**Table 1-2—U.S. EPR Conformance with Standard Review Plan (NUREG-0800)**

**Table 19.1-102—Summary of Insights from the PRA for the U.S. EPR**  
**Sheet 1 of 11**

**19.1.4.1.2 Results from the Level 1 PRA for Operations at Power**

Figure 19.1-19—U.S. EPR Level 2 Fire Events Uncertainty Analysis Results – Cumulative Distribution Function for Fire Events LRF

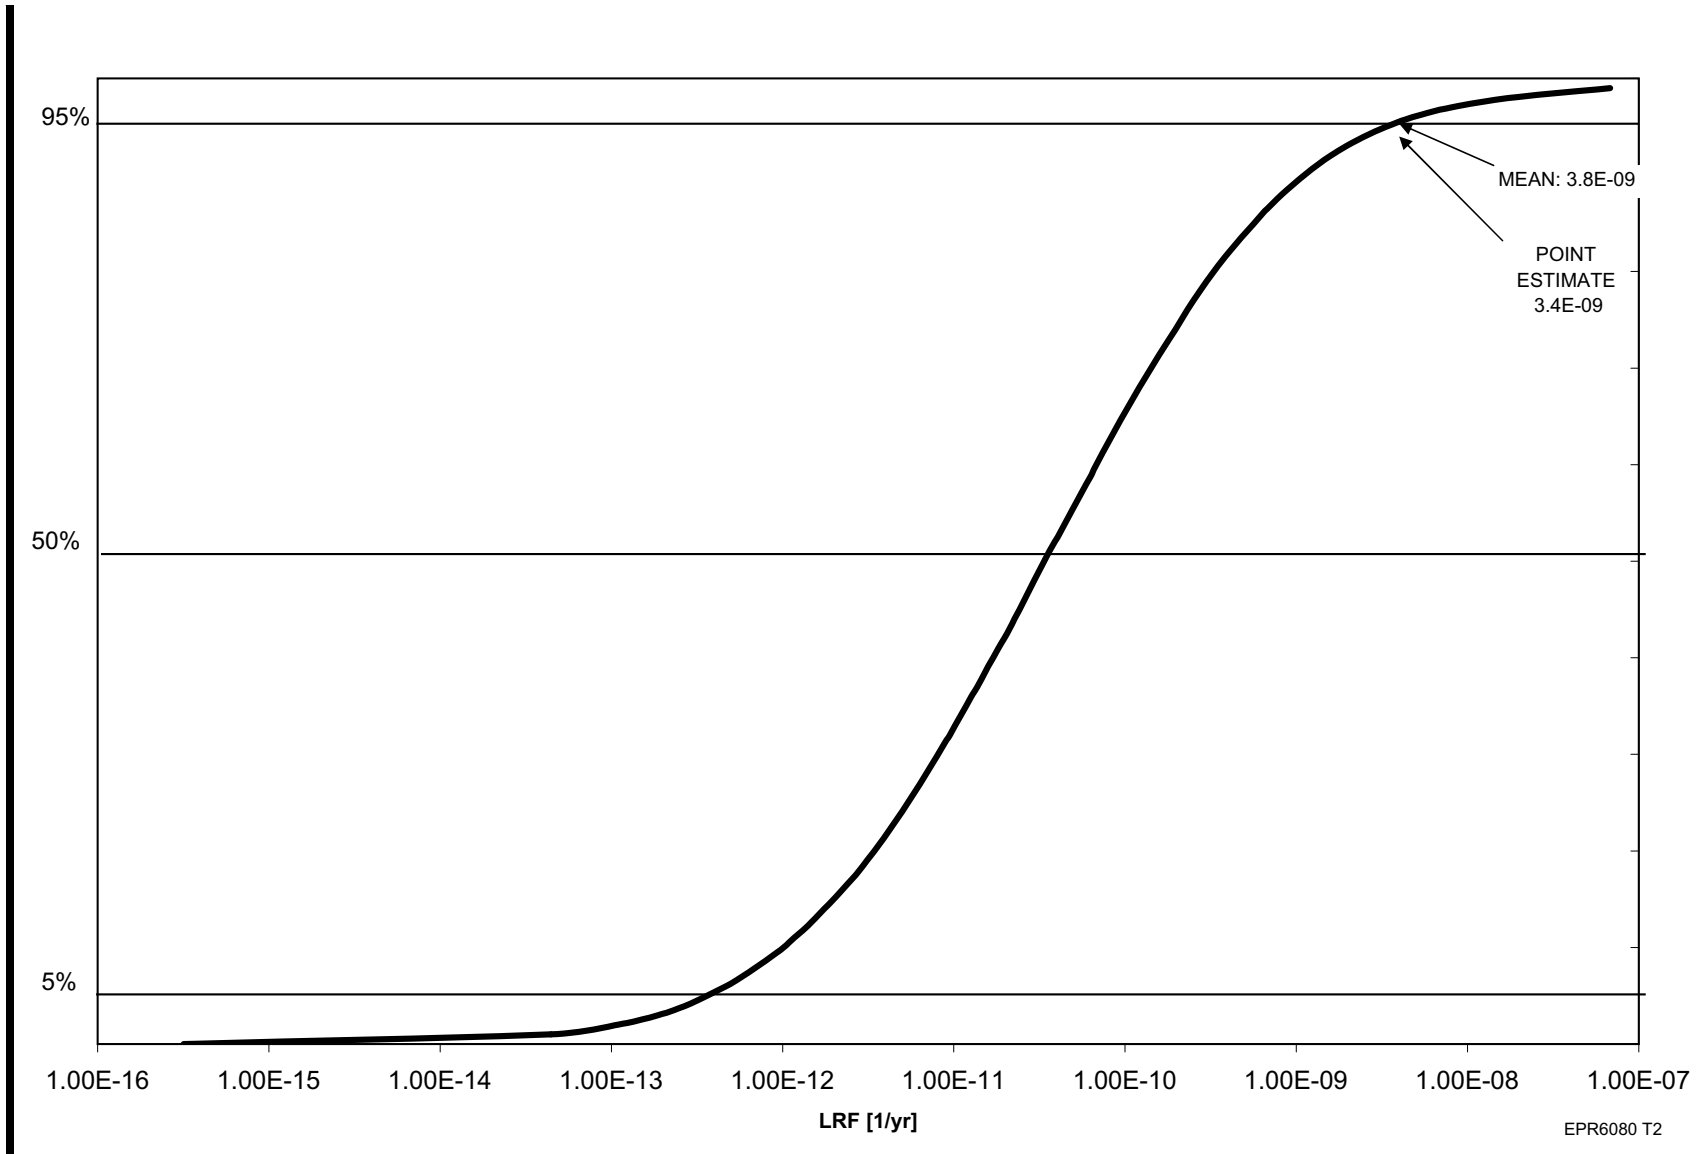
~~The results of the uncertainty evaluation for the LRF for fires are presented in Figure 19.1-19—U.S. EPR Level 2 Fire Events Uncertainty Analysis Results—Cumulative Distribution Function for LRF. The fifth percentile for the LRF is 1.4E-10/yr. The ninety-fifth percentile is 1.3E-8/yr. This ninety-fifth percentile LRF value is nearly two orders of magnitude below the goal of 1E-6/yr.~~

The results of the uncertainty evaluation for the Level 2 Fire Events LRF are presented in Figure 19.1-19—U.S. EPR Level 2 Fire Events Uncertainty Analysis Results – Cumulative Distribution for LRF.

Figure 19.1-23—U.S. EPR Level 1 Shutdown Events Uncertainty Analysis Results – Cumulative Distribution for Low Power and Shutdown CDF

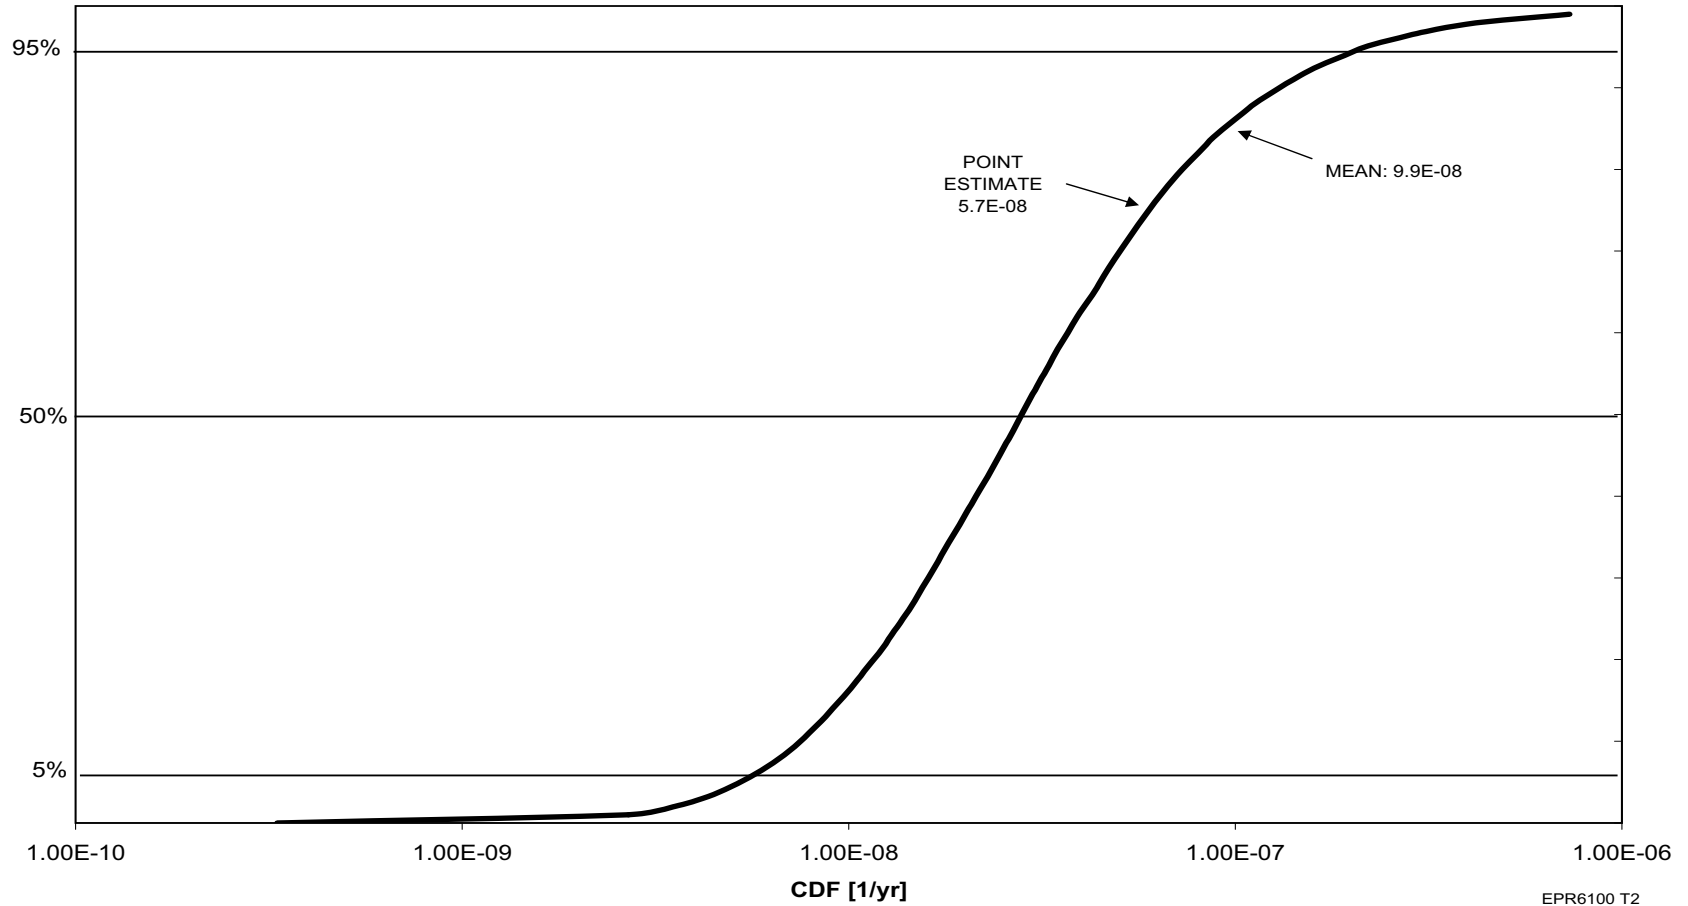
~~The result of the uncertainty analysis for LPSD operation is shown in Figure 19.1-23—U.S. EPR Shutdown Events Uncertainty Analysis Results—Cumulative Distribution for Low Power and Shutdown CDF. The distribution shown only incorporates parametric uncertainty. There is a relatively large ratio between the mean and the point estimate, indicating a larger impact from the “state of knowledge” correlation.~~

The results of the uncertainty evaluation for the LPSD operation CDF are presented in Figure 19.1-23—U.S. EPR Level 1 Shutdown Events Uncertainty Analysis Results – Cumulative Distribution for Low Power and Shutdown CDF.

Figure 19.1-29— U.S. EPR Level 1 Internal Events Total Uncertainty Analysis Results – Cumulative Distribution for All Internal, Fire and Flood Events CDF

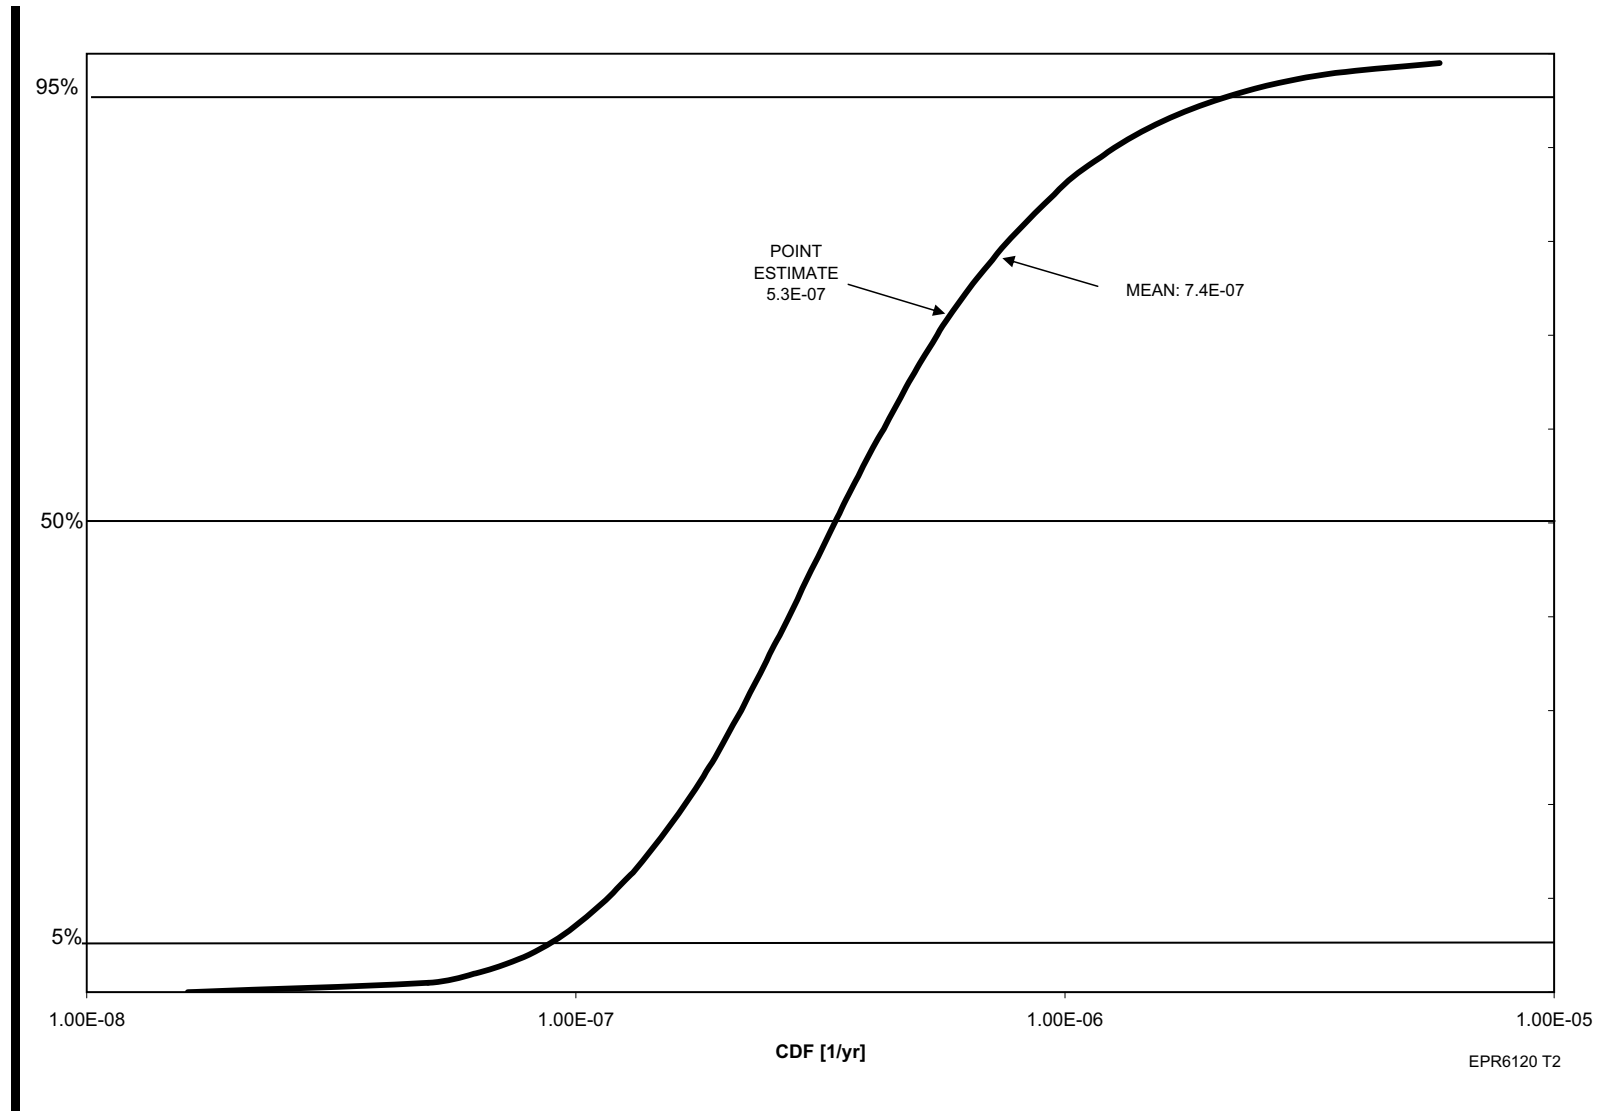
The results of the Level 1 uncertainty analysis for all internal, fire, and flood initiators are shown in Figure 19.1-29—U.S. EPR Level 1 Internal Events Total Uncertainty Analysis Results – Cumulative Distribution for All Internal, Fire and Flooding Events CDF. ~~Three distributions are presented: one that only incorporates parametric uncertainty, one that incorporates the three cases of modeling uncertainty in addition to the parametric uncertainty, and one that incorporates parametric uncertainty, but without a distribution for the diesel generators failures to run (a point estimate is used only). The inclusion of modeling uncertainties increases the point estimate by about a factor of four. The dominant contributors are assumptions on the EFW success criteria uncertainty, and the uncertainty in the heatup of electrical equipment on a loss of HVAC. The elimination of uncertainty in the diesel generator failure to run failure rate, significantly reduces the impact from “state of knowledge” correlation, reducing the mean CDF by a factor of four, due to the high level of redundancy and the high importance of the diesel generators. Treatment of parametric uncertainty is described in Section 19.1.4.1.2.7.~~

Figure 19.1-30—U.S. EPR Level 2 Internal Events Total Uncertainty Analysis Results – Cumulative Distribution for All Internal, Fire and Flood Events LRF

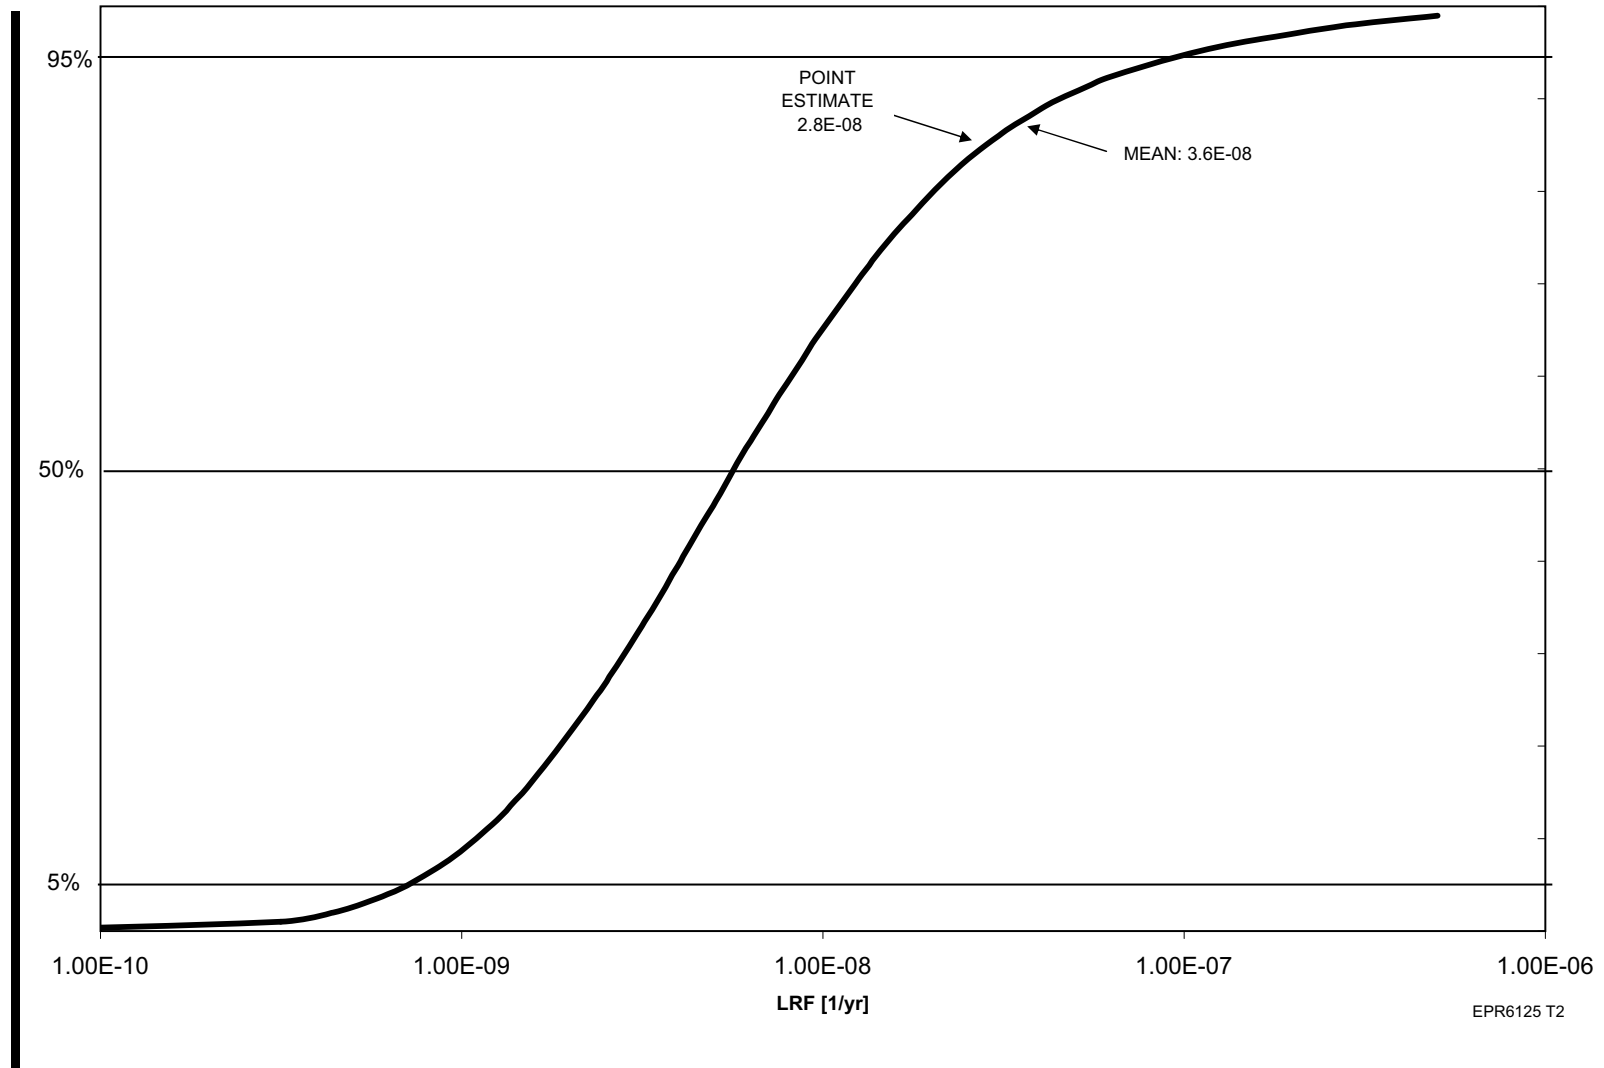
The results of the uncertainty analysis for LRF from all internal, fire, and flooding initiators are shown in Figure 19.1-30—U.S. EPR Level 2 Internal, ~~Fire, and Flooding~~ Events Total Uncertainty Analysis Results—Cumulative Distribution for all Internal, Fire and Flood Events LRF.
